ecewed by OCD: 5/8/2021 10:26:58 AM U.S. Department of the Interior BUREAU OF LAND MANAGEMENT		Sundry Print Report 01/27/2021	
Well Name: SMITH FEDERAL GAS COM	Well Location: T22S / R23E / SEC 12 / SENW /	County or Parish/State: EDDY / NM	
Well Number: 3	Type of Well: CONVENTIONAL GAS WELL	Allottee or Tribe Name:	
Lease Number: NMNM0251099A	Unit or CA Name: SMITH FED GAS COM 2	Unit or CA Number: NMNM85354	
US Well Number: 300153068700S1	Well Status: Producing Gas Well	Operator: EOG RESOURCES INCORPORATED	
	Accepted for record – NMOCD gc 2/11/2021

Type of Action Plug and Abandonment Time Sundry Submitted: 11:00

PLUG AND ABANDONMENT CONDITIONS OF APPROVAL

OPERATOR'S NAME:	EOG Resources Incorporated
LEASE NO.:	NMNM0251099A
WELL NAME & NO.:	Smith Federal Gas Com 3
US Well Number:	300153068700S1
LOCATION:	Section 12, T.22 S., R.23 E., NMPM
COUNTY:	Eddy County, New Mexico

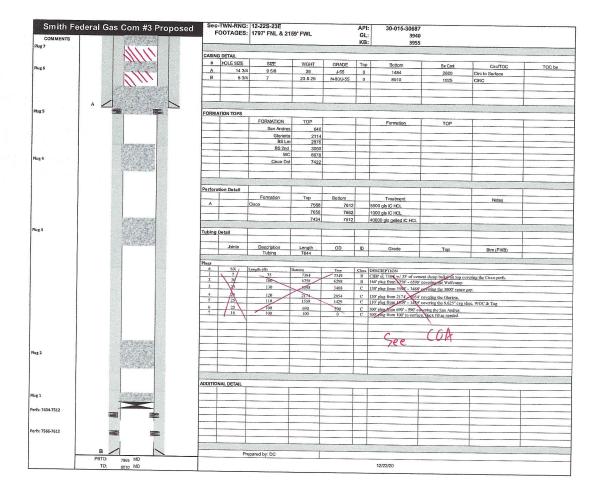
- 1. MIRU all safety equipment as needed. NU BOP. POOH with production equipment.
- Set a CIBP at 7384 ft with 35 ft Class H cement on top to 7349 ft. This will cover Cisco perfs. Leak Test CIBP
 Spot a 30 sx Class H compart plus from CIEP ft.
